Access Compliance Report

Public Rights-of-Way

(Curb Ramps)

Intersection ID: 5111	Main Street: HAYBRIDGE_RD	Cross Street: HUBBARD_RD	Location: NW
ADA ID: 254794F353DB	Ramp Type: PerpDiag	Initial Pass/Fail: Fail	Overall Compliance: No
			Severity Score: 26.25

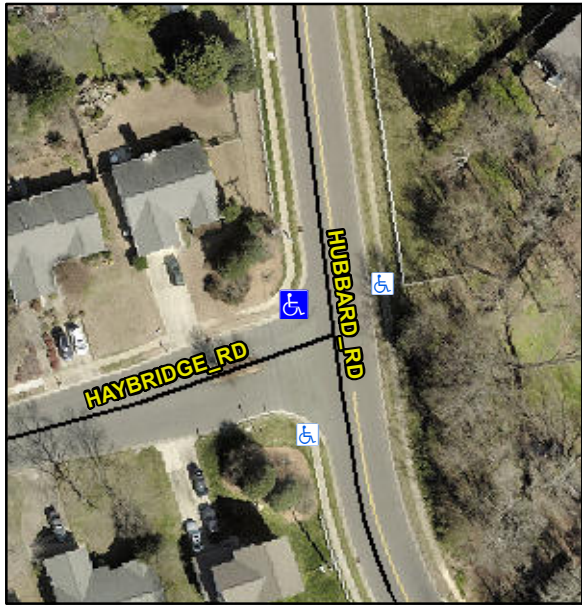
N/A	Shared Landing?	N/A				
		N/A	Gutter Ponding?	N/A	N/A	N/A	Gutter Slope (%)	N/A
		N/A	Gutter Lip Ht (in)	N/A	N/A	N/A	Gutter X Slope (%)	N/A
		N/A	Painted X Walk1?	No	N/A	N/A	Painted X Walk2?	No
			X Walk 1 Direction	To S			X Walk 2 Direction	To E
		N/A	X Walk 1 Width (in)	N/A	N/A	N/A	X Walk 2 Width (in)	N/A
			X Walk 1 Slope (%)	4.5			X Walk 2 Slope (%)	2.2
			X Walk 1 X Slope (%)	4.4			X Walk 2 X Slope (%)	6.3
		N/A	Ramp inside XWalk1?	N/A	N/A	N/A	Ramp inside XWalk2?	N/A
			Road Slope (%)	6.2	N/A	N/A	Clear Space?	N/A
			Road X Slope (%)	2.5	N/A	N/A	Clear Space to XWalk (in)	N/A
		N/A	Any Obstructions?	N/A	N/A	N/A	Storm Grate/Utility Hazard?	N/A
			Obstruction Type				Storm Grate/Utility Type	
				N/A				N/A
						Yes	Surface Condition? (G/P)	Good
Surveyor Notes:								
N/A								
PROW/ADA:								
Not Found, R304.2.2, R304.5.3								
Total Cost:		\$	3200.00

Codes/Mitigation Info/Possible Solution			Field Measurements/Component Compliance					
 <p>Street 1 Name HAYBRIDGE RD</p> <p>Stop Condition-Street 2 StopSign</p> <p>Street 2 Name HUBBARD RD</p> <p>Stop Condition-Street 1 None</p>	Possible Solutions:		Compliance	Description	Data	Compliance	Description	Data
	Remove & Replace Curb Ramp With Two New Directional Ramps or Equivalent.		N/A	Ramp Length (in)	48.0	No	Ramp Slope (%)	20.0
			Yes	Ramp Width (in)	50.0	No	Ramp XSlope (%)	4.7
			N/A	Flare Type LT	N/A	N/A	Flare Type RT	N/A
			N/A	Flare Slope LT (%)	N/A	N/A	Flare Slope RT (%)	N/A
			N/A	Flare Traversable LT?	N/A	N/A	Flare Traversable RT?	N/A
			N/A	Landing Length (in)	N/A	N/A	DWS Provided?	N/A
			N/A	Landing Width (in)	N/A	N/A	DWS Contrast?	N/A
			N/A	Landing Slope (%)	N/A	N/A	DWS Length (in)	N/A
			N/A	Landing X Slope (%)	N/A	N/A	DWS Full Width?	N/A
		N/A	Landing Curb? (Y/N)	N/A	N/A	DWS Offset (in)	N/A	N/A
